# HISTORIC LANDMARK COMMISSION STAFF REPORT

## Park Strip Raised Planter Boxes Minor Alteration

PLNHLC2014-00603

163 D Street

## Site Plan

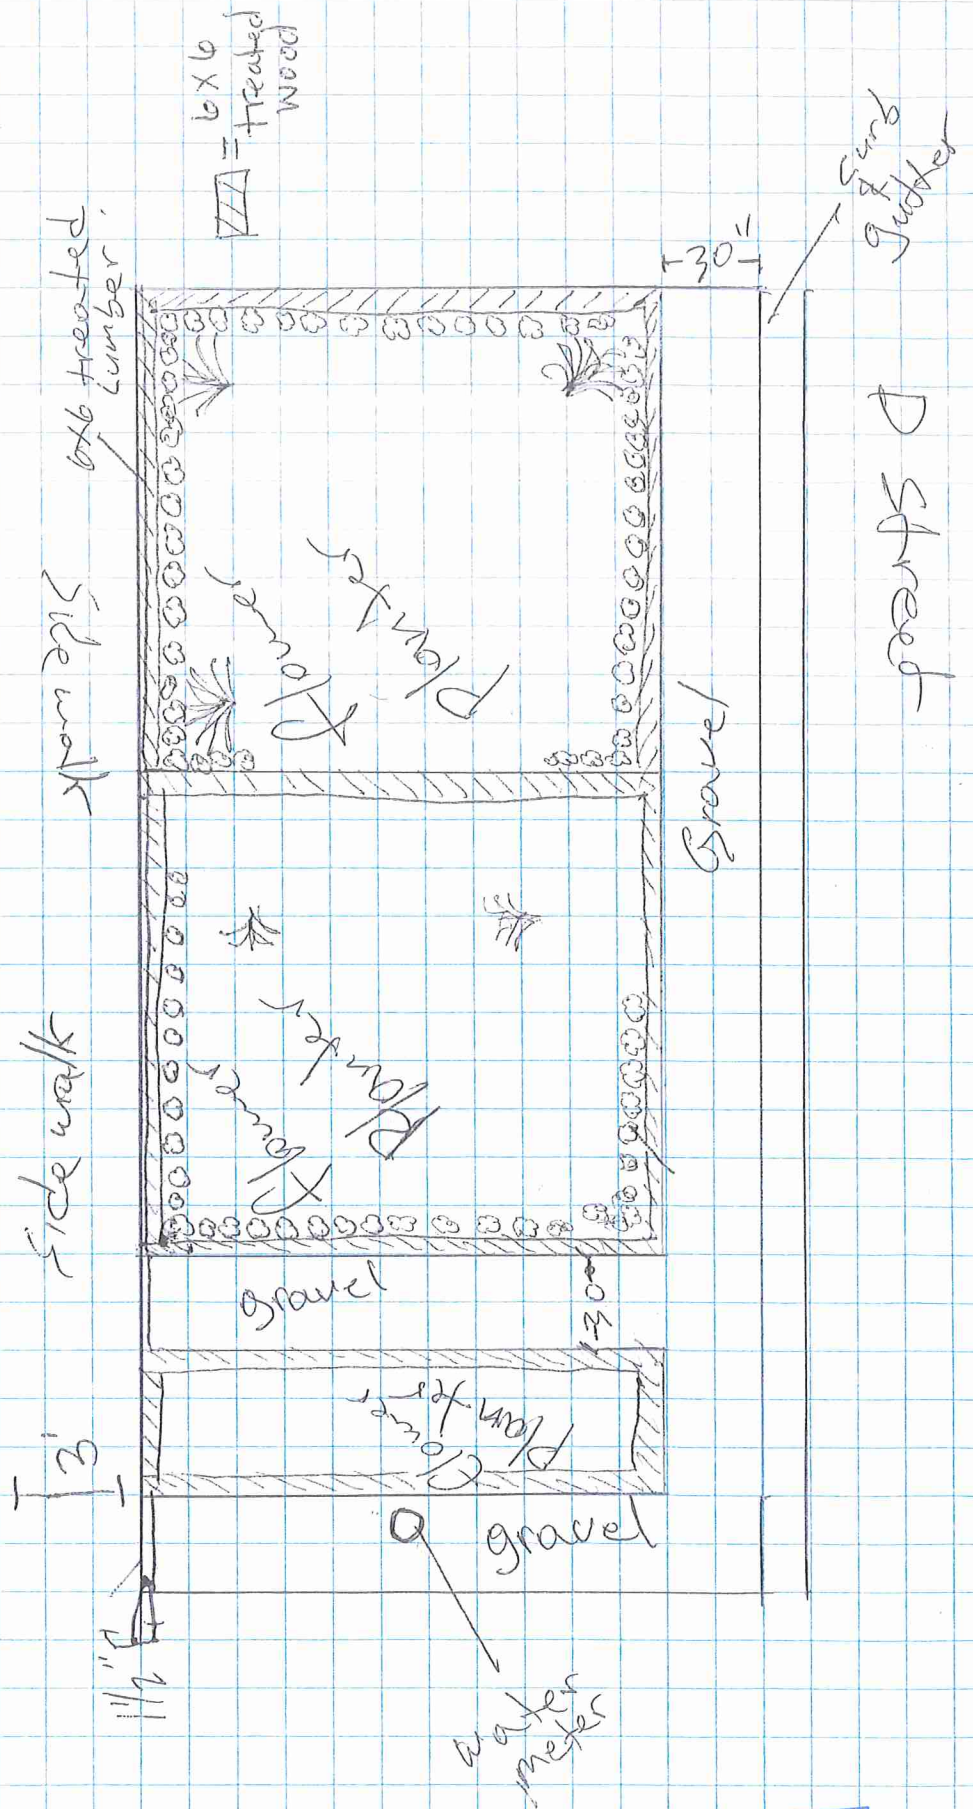
The applicant is requesting a Certificate of Appropriateness for three raised planter boxes currently located in the public right-of-way. The planter boxes are specifically located between the park strip and the curb. The park strip in front of the subject property is approximately 300 square feet. The two larger boxes are approximately 9.5 feet by 9.5 feet each (approximately 180 square feet total) and the smaller one is approximately 3.5 feet by 9.5 feet (approximately 33 square feet). The planter boxes cover approximately 71% of the park strip area and the remaining 29% is filled with gravel. All three of the boxes are contained or surrounded by treated wood. Each of the wood beams is approximately six inches in height. The planter boxes vary in height between twelve inches to 36 inches. In between the larger and small boxes, there is a three foot wide gravel walking path that connects the sidewalk to the curb or street.

**Analysis:** Staff has reviewed the zoning requirements for park strip landscaping as they relate to this request. The raised planter boxes are a new structural encroachment in the park strip, which is not allowed unless a revocable permit has been issued. The applicant attended a Design Review Team (DRT) meeting to obtain a revocable permit and received several comments. Overall, the comments were general in nature and state that standard sections of the City Code would need to be complied with should the project be approved. However, it needs to be noted that no revocable permit can be issued until a Certificate of Appropriateness is obtained due to the location of the property within a historic district.

*View looking northwest from the street.*

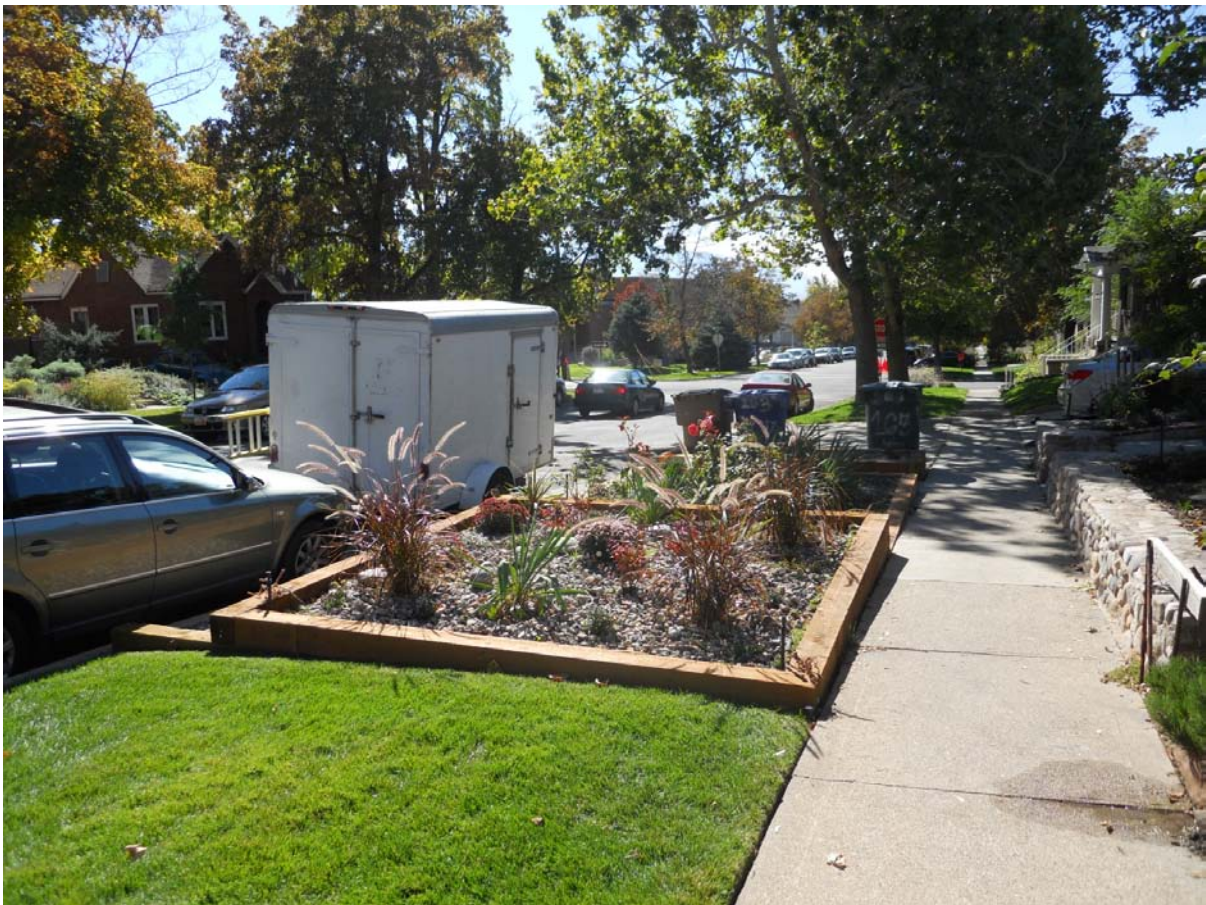
Because the lot slopes from the northern edge to the southern edge, the heights of the raised planter boxes vary. Along the northern edge of each box, the frame of the box is almost flush with the sidewalk. As they move south, they get taller in height. Each piece

of the wood frame is approximately six by six inches. The tallest point of the boxes is at the southern edge of the property and with three wood frames stacked on top of each other, the raised planter box is approximately 18 inches in height. Because the tallest portion of the most southern box is 18 inches in height, and it is within the sight distance triangle area, there would not be any plantings permitted in this area unless they are flush with the top of the planter boxes.

Plants up to 36 inches in height may be used as individual specimens or accent plants when not located within sight distance areas. Due to the varied height of the planter boxes, it is possible that some of the plants will need to be removed as they are taller than 36 inches when added to the height of the planter boxes. In addition, the proposed raised boxes and plantings must not be spaced in a way that results in a solid mass, creating a visual barrier between the street and sidewalk.
